CONTRACT CHANGE ORDER NO. \_\_\_\_\_  
 SHEET \_\_\_\_\_ OF \_\_\_\_\_

**UNDERGROUND DUCT BANKS AND MANHOLES**  
 SCALE: 1:200

**E-11A**

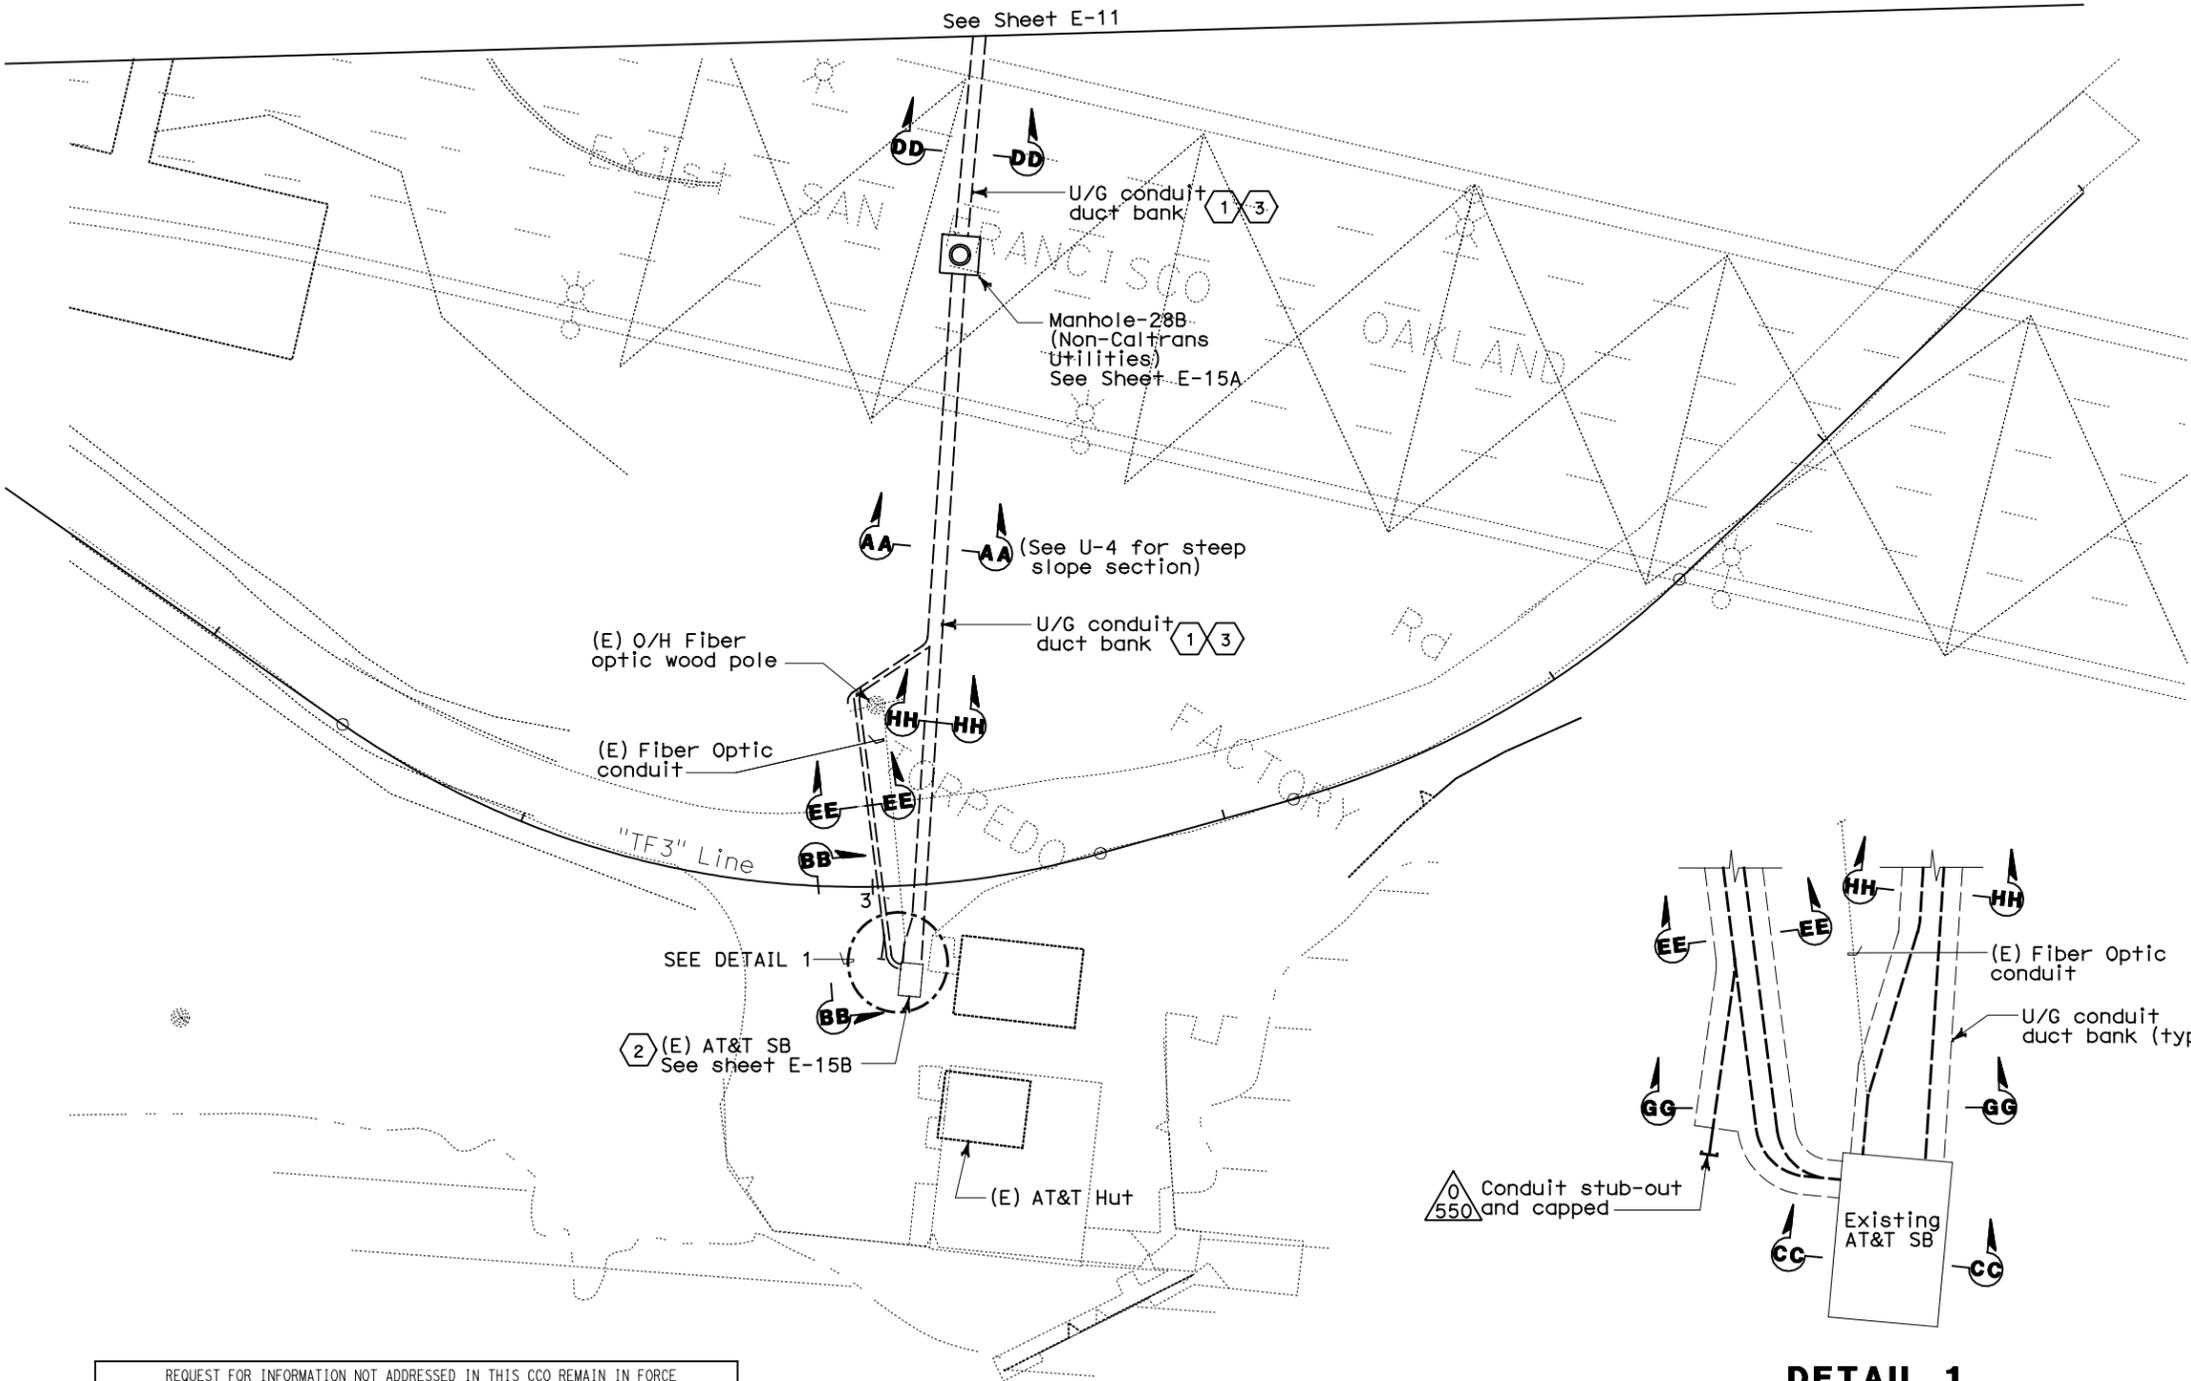
REQUEST FOR INFORMATION NOT ADDRESSED IN THIS CCO REMAIN IN FORCE				
MARK	DATE	DESCRIPTIONS	BY	CH'D
△	08/08/11	W2 DUCT BANKS REINFORCEMENT	EJL	RG
			TW	205
			BY	CH'D
			CCO#
